DEVELOPMENT SERVICES DEPARTMENT STAFF REPORT

Project Name: Nove of Margate

DRC #: 23-400013

Application Type: Rezoning

[Applicant’s Open Space Exhibit]

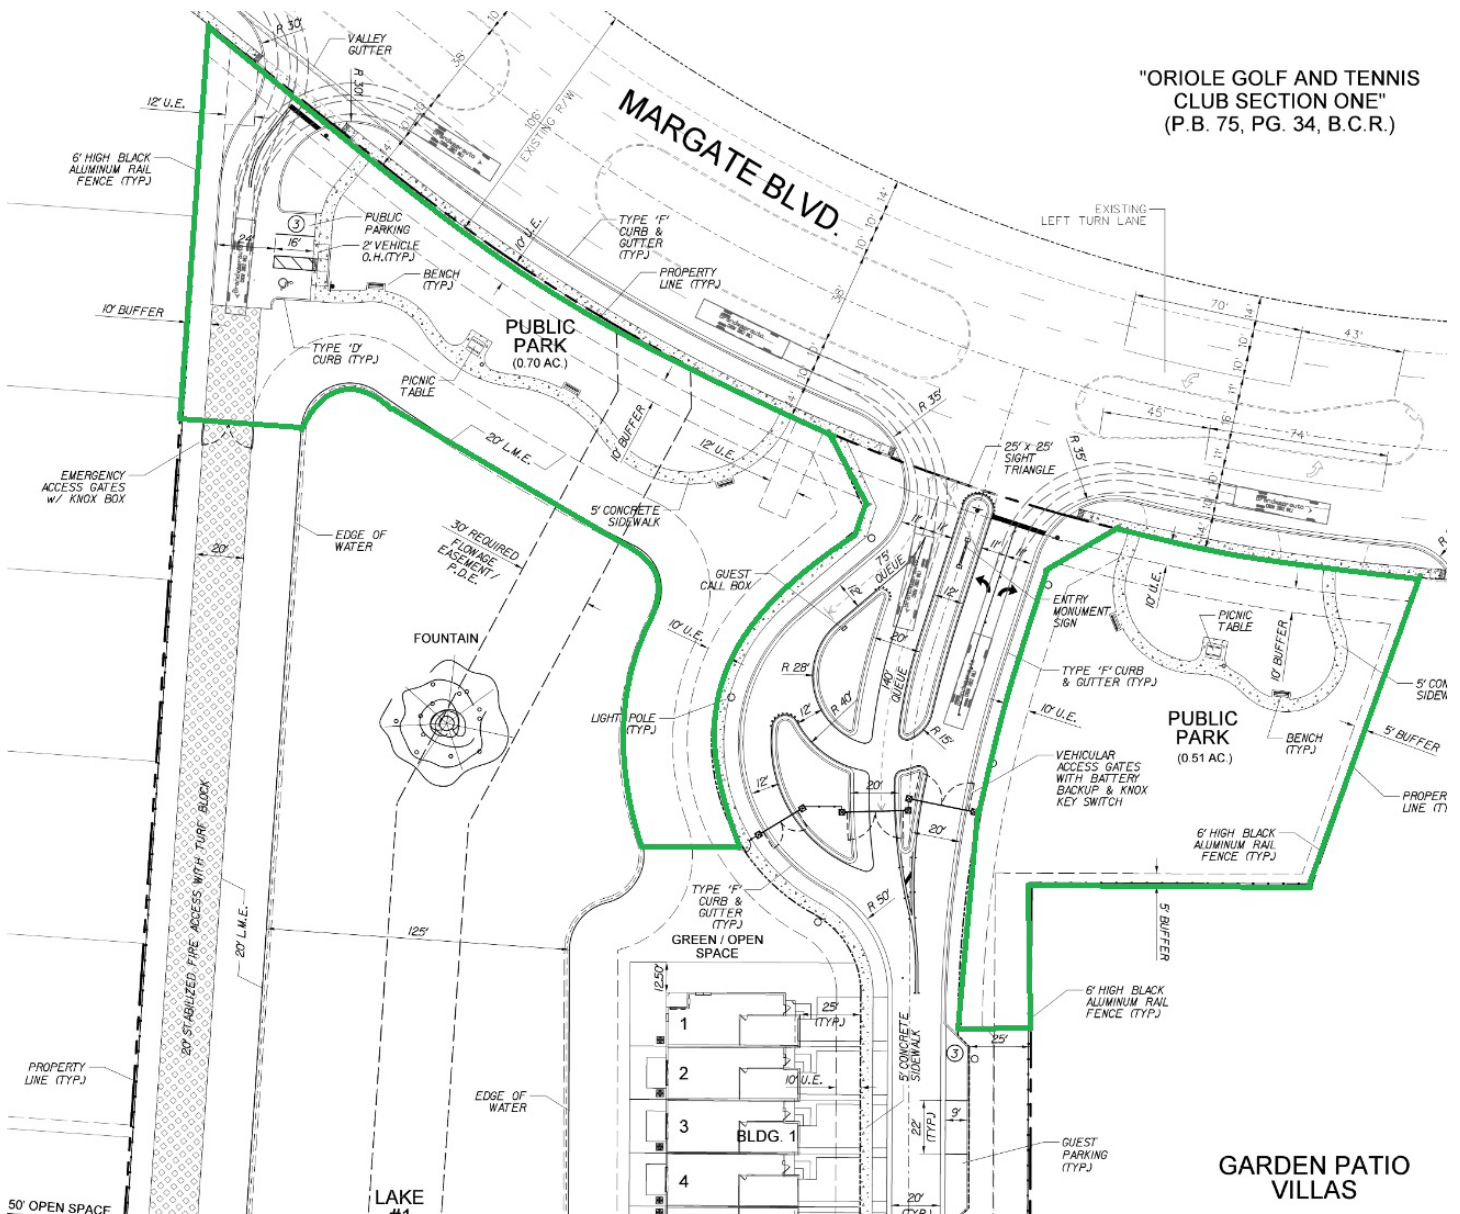
Either cite the verbiage in Sec. 19.11 (MZC) that allows this area to credit the open space requirement or remove it from the tabulation.

Either cite the verbiage in Sec. 19.11 (MZC) that allows this area to credit the open space requirement or remove it from the tabulation.

Either cite the verbiage in Sec. 19.11 (MZC) that allows this area to credit the open space requirement or remove it from the tabulation.

Either cite the verbiage in Sec. 19.11 (MZC) that allows this area to credit the open space requirement or remove it from the tabulation.

Revise gross acreage of 'residential lot' to only include fenced in portions of yards, per Sec. 19.11 (MZC).

Tabulation of 'other open space' includes a number of areas not specifically described in Section 19.11 (MZC). Revise.

'Public park' has the same credit value as 'recreation'. See Sec. 19.11 (MZC). Revise tabulation.

Response: A new sheet, Open Space Exhibit (Sheet SP-06) has been provided with this submittal. This plan shows all the areas included in the calculations in green. The definition of Open Space listed in Section 19.3 of the City Code permits this section to be counted towards the open space. Specifically, the definition of Open Space is as follows: "Open space: A generally unobstructed parcel or area of land permanently dedicated or reserved for the use and enjoyment of owners and occupants of the land within the PUD. Required open space shall be of a pervious nature and shall not be used for private roadways open to vehicular circulation; off-street parking or loading berths, lakes, canals, and other features may be considered as required open spaces to the extent of the limitations contained herein at Section 19.11, "Open Space Requirement and Computation." As this area is a generally unobstructed area of land permanently dedicated for the use of and enjoyment of the owners within the PUD, it meets the definition of Open Space and can therefore be counted towards meeting the open space requirements. More importantly, the PUD provides substantially more open space than required by Code.

Response: A new sheet, Open Space Diagram (Sheet SP-06) has been provided with this submittal.

This plan shows all the areas included in the calculations in green. The definition of Open Space listed in Section 19.3 of the City Code permits this section to be counted towards the open space. Specifically, the definition of Open Space is as follows: "Open space: A generally unobstructed parcel or area of land permanently dedicated or reserved for the use and enjoyment of owners and occupants of the land within the PUD. Required open space shall be of a pervious nature and shall not be used for private roadways open to vehicular circulation; off-street parking or loading berths, lakes, canals, and other features may be considered as required open spaces to the extent of the limitations contained herein at Section 19.11, "Open Space Requirement and Computation." As this area is a generally unobstructed area of land permanently dedicated for the use of and enjoyment of the owners within the PUD, it meets the definition of Open Space and can therefore be counted towards meeting the open space requirements. More importantly, the PUD provides substantially more open space than required by Code.
